Department of Natural Resources and Parks  
Wastewater Treatment Division

May 8, 2020

### North Mercer Island Interceptor and Enatai Interceptor Upgrade Project – Response to City of Mercer Island Request for Information 2 (PAE19-001, CAO19-020, and SHL19-019)

DCN:	DATE: 05/02/2019
PROJECT FILE NO:	DRAWING NO: <b>TC101</b>
SHT NO / TOTAL	REV NO:

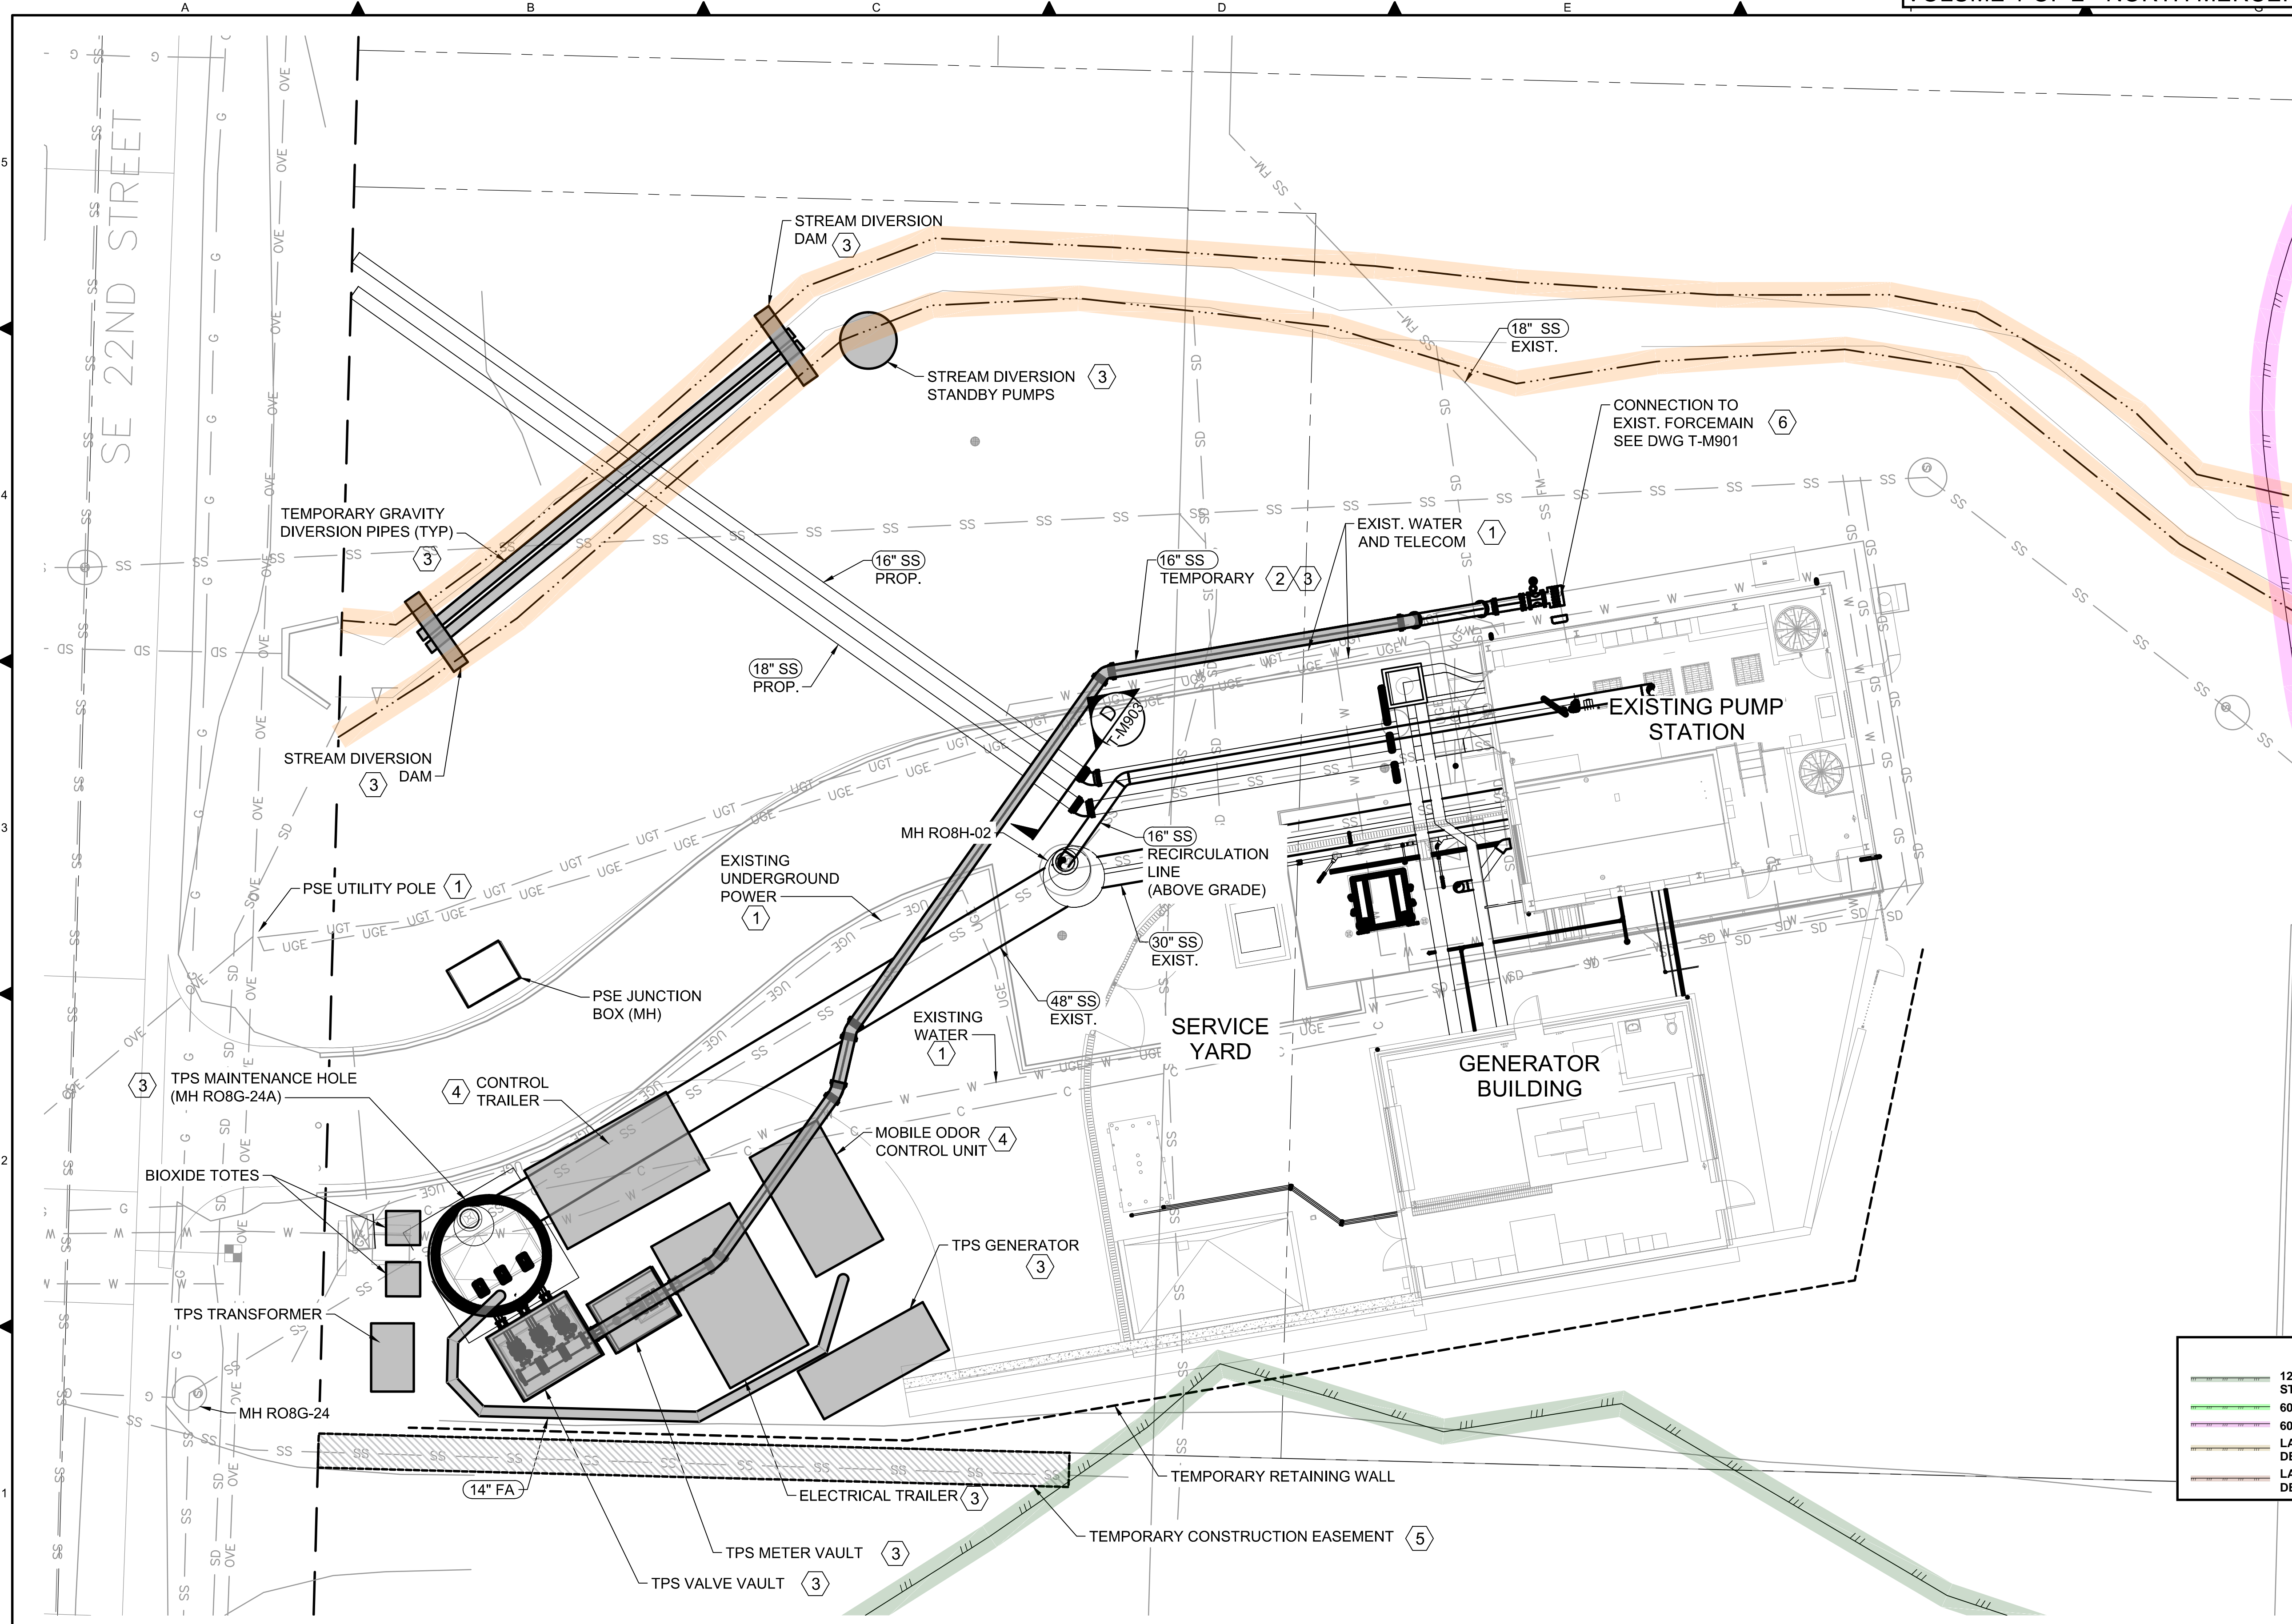
**Mercer Island Comment:** It is unclear from the project materials how the proposed temporary improvements along SE 22<sup>nd</sup> St meet the yard standards in MICC 19.02.020(C)(3). Application materials state that temporary improvements, including a standby generator about 14 feet tall, an odor control unit about 8 feet tall, and a temporary electrical transformer about [6] feet tall will be within the front yard setback.

“Yard” is defined as “required to be kept open by the yard requirements prescribed herein.” MICC 19.02.020(C)(3) lists structures that are allowed to be within required yard, it is not clear from the application materials how the code is proposed to be met.

Options I can think of to demonstrate code compliance include:

- a. An explanation of how the proposed temporary improvements fall into an exception (e.g. MICC 19.02.020(C)(3)(e), if this applies);
- b. Moving the temporary improvement out of the front yard setback; or
- c. Applying for a setback deviation, pursuant to MICC 19.06.110.

**Response:** *Based on our review of MICC 19.02.020(C)(3)(e), it appears that all of the temporary improvements (e.g., standby generator, odor control unit, and electrical transformer) meet the specified*

*requirements. They can all be categorized as mechanical and electrical equipment. All of the equipment is specified to meet all noise levels as specified under WAC 173-60-040. Finally, the equipment will be located more than 3 feet from any lot line, per Sheet T-C101 in the Development Plan Set (attached).*
